CITY AIRPORT DEVELOPMENT PROGRAMME
(CADP1) S73 APPLICATION

Volume 2: Appendices
Appendix 3.8 Scoping Response
Comments

London City Airport Scoping Response Comments

Table 1.1: Assessment of Applicant's Response to Recommendations

Figure 1.1: Modelling Scenario for material change to a consented scheme

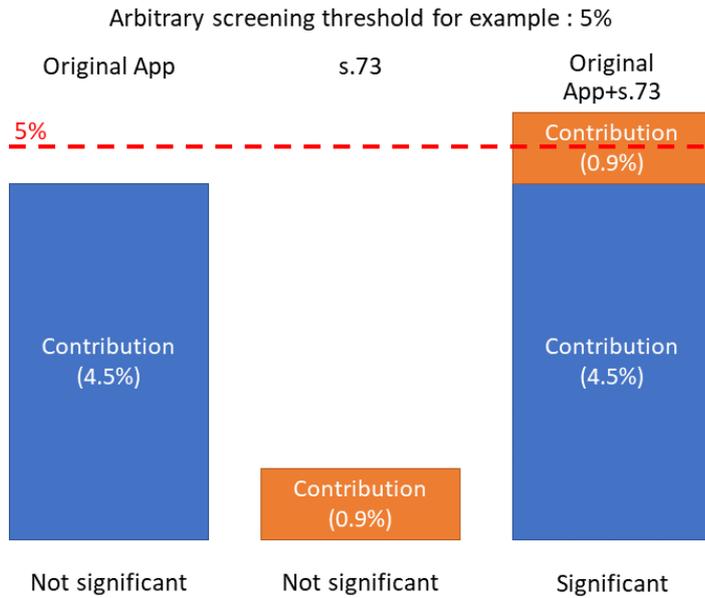
Code	Original Recommendation	Applicant Response	Reassessment Conclusion
	<p>The assessment should not look solely at the impact of the s73 proposals; the assessment should consider the combined impacts of the consented development and the s73 proposals. This will enable the impacts of the variation to be assessed to demonstrate that it causes no material change to the conclusions of the consented scheme. It will also ensure that consideration can be given to the mitigation of any identified significant impacts (AQ11).</p> <p>To fully understand the impacts of the s73 proposals the impact of the following scenarios will need to be modelled 1) 2019 and future baselines, 2) future years with the consented development following the restarted construction programme and 3) future years with the consented development and the s73 proposals. Scenarios 2 and 3 should also consider the cumulative impacts of other developments (AQ12).</p>
